From: Mess, Camie
Sent: Thursday, April 26, 2018 2:37 PM
To: jeff@latitude38llc.com
Cc: Werner, Jeffrey B
Subject: BAR Actions - March 20, 2018 - 413 Ridge Street

BAR 17-11-04
413 Ridge Street
Tax Parcel 290136000
Jeffrey Erkelens, Owner/ Jeffrey Erkelens, Applicant
Proposed Rear Elevation Changes – Details

**CITY OF CHARLOTTESVILLE
BOARD OF ARCHITECTURAL REVIEW
STAFF REPORT
March 20, 2018**

BAR 17-11-04
413 Ridge Street
Tax Parcel 290136000
Jeffrey Erkelens, Owner/ Jeffrey Erkelens, Applicant
Proposed Rear Elevation Changes – Details

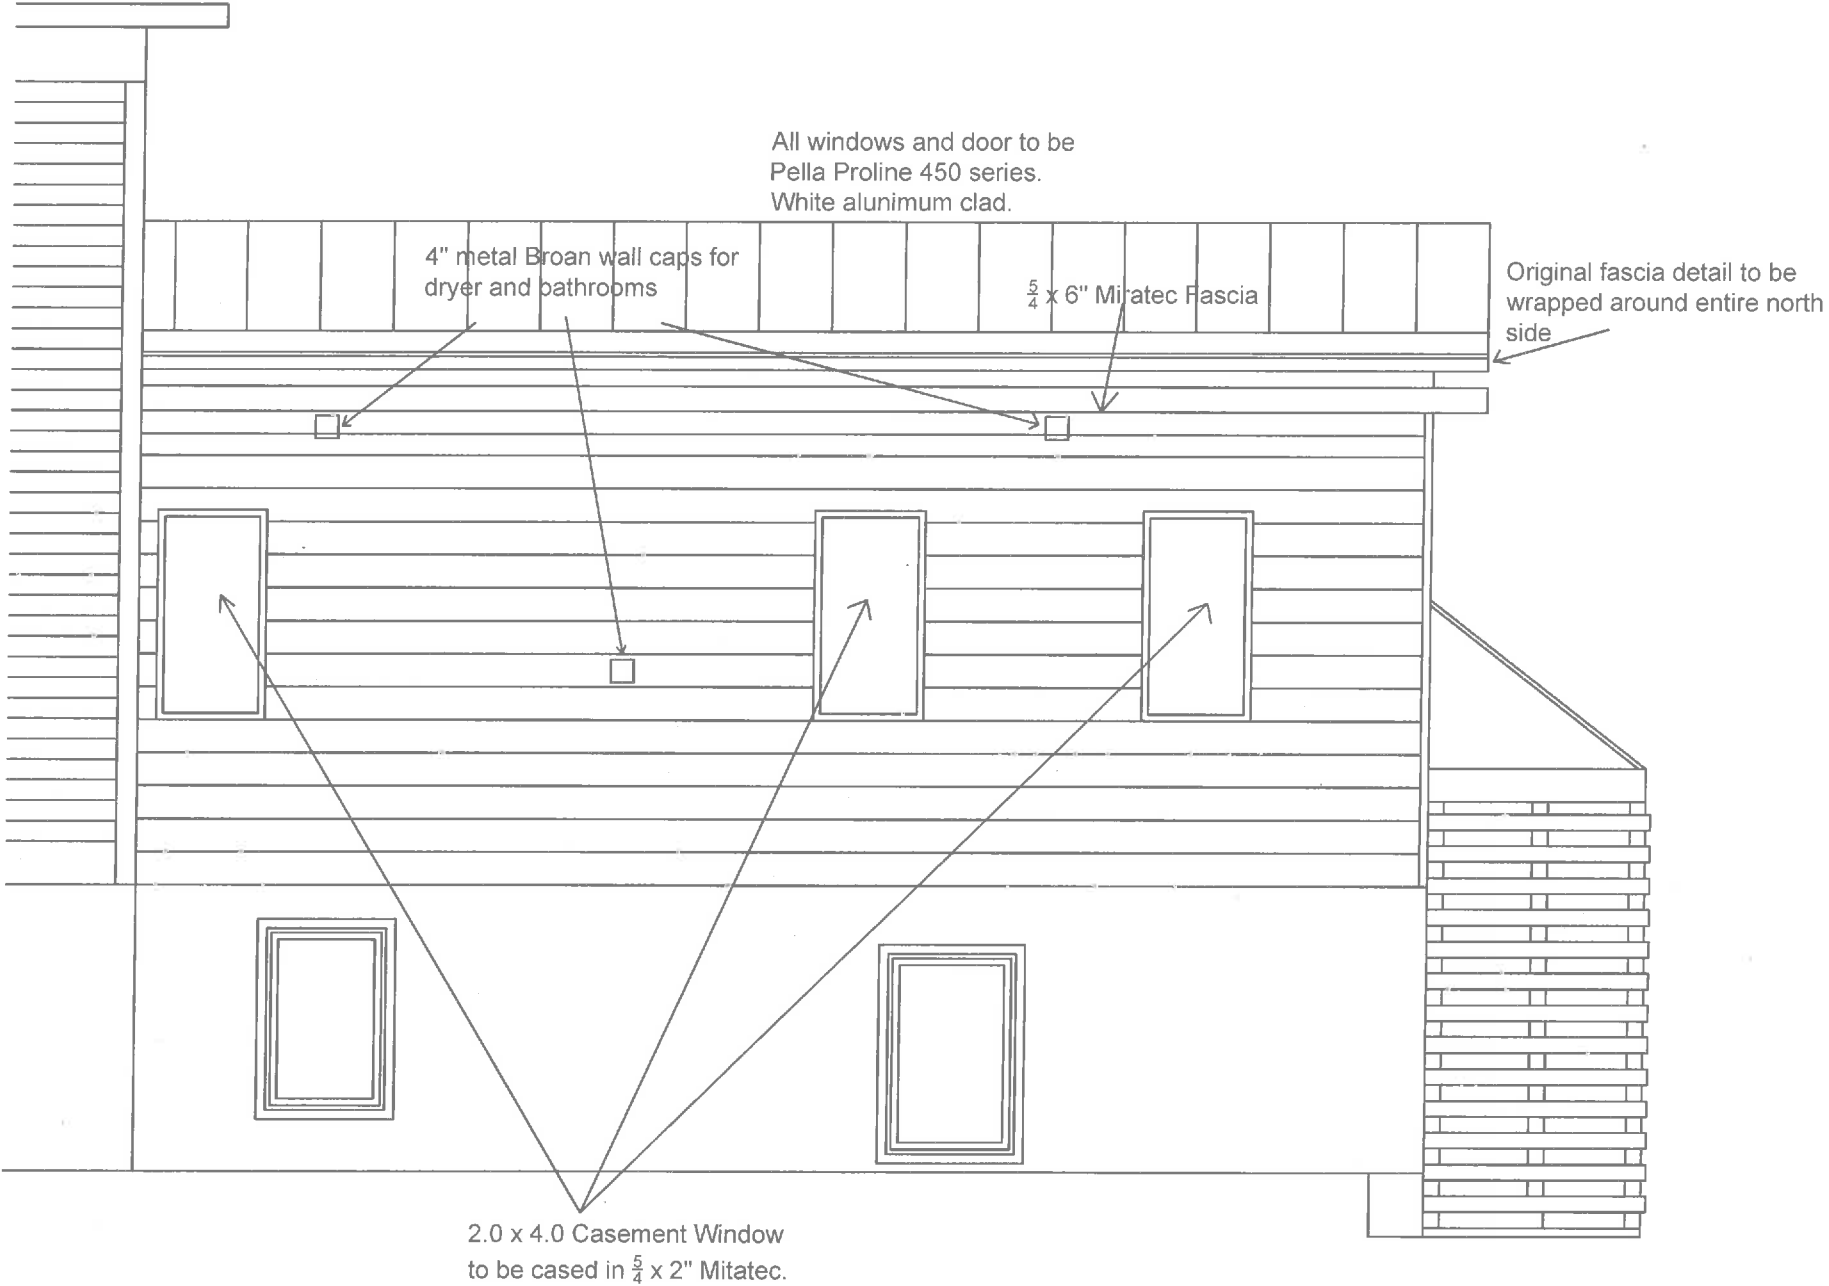
In staff's opinion the suggested changes to the COA are appropriate. The windows will not be visible from either Oak and Ridge Street, changing the roofline on the non-historic addition will further distinguish it from the historic structure, and the paint color is appropriate.

Schwarz moved: Having considered the standards set forth within the City Code, including City Design Guidelines for Rehabilitations and New Construction and Additions, I move to find that the proposed changes satisfy the BAR's criteria and guidelines and are compatible with this property and other properties in the Ridge Street ADC district, and that the BAR approves the application as submitted. Earnst seconded. Approved (7-0).
